MILITARY SPECIFICATION

RAILWAY CAR, FLAT, DEPRESSED CENTER, HEAVY DUTY,

150 TON, DOMESTIC SERVICE

This amendment forms a part of Military Specification MIL-R-52768(ME), dated 21 November 1973, and is approved for use by all Departments and Agencies of the Department of Defense.

FIGURE 1a.

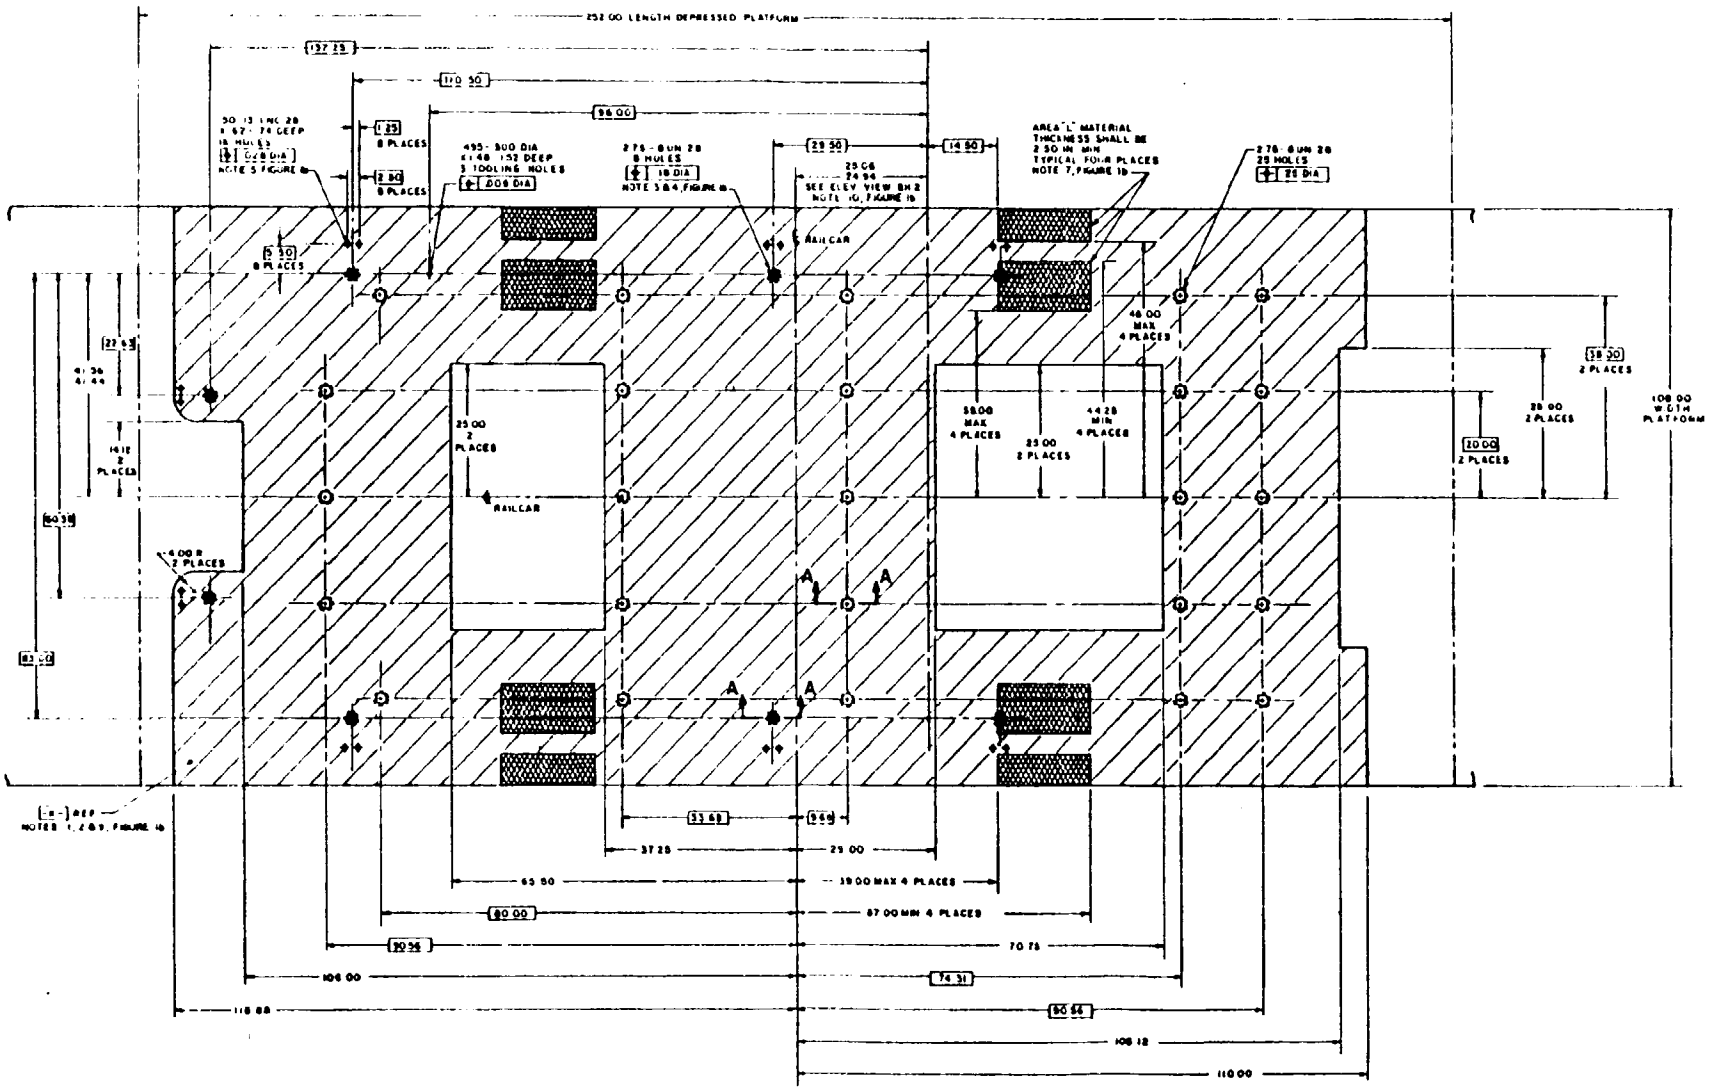
3.8.1, add: "Deck arrangement shall accomodate container mounting Configuration A, B or C as indicated on Figure 1b (see 6.2). All cars shall be furnished with 33 bosses (see Figure 1a)."

"Figure 1a, X-2634 " is replaced by "Figure 1a, X-2634A ".
